SERVICE BULLETIN No. 300-1-95

Subject: Seat Attachment
Models affected: EA-300 EA-300S
Serial numbers affected: V1,01 through 63 01 through 22
Purpose: Cracks have been reported
Approval: The technical content of this Service Bulletin have been approved by LBA.

Fig 01 Potential Crack Area

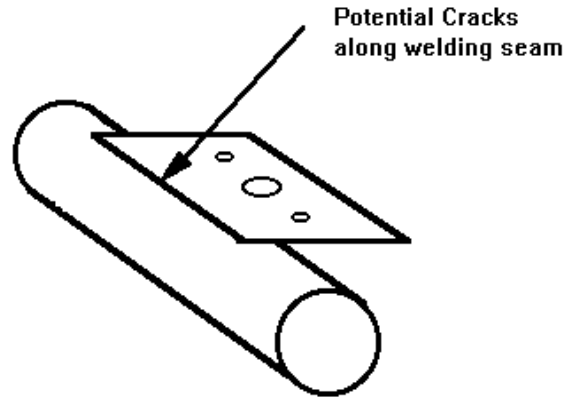
- On EA-300 seat attachments front seat (wood and carbon seat) and rear seat (wooden seat only) as well as on EA-300S seat attachments cracks have been observed, refer to Fig. 01.
- In series production a modification has been introduced to strenghten the attachments.
- Operators and maintenance shops are advised to check for cracks at those attachments and to strenghten the attachments as shown on Fig 02.
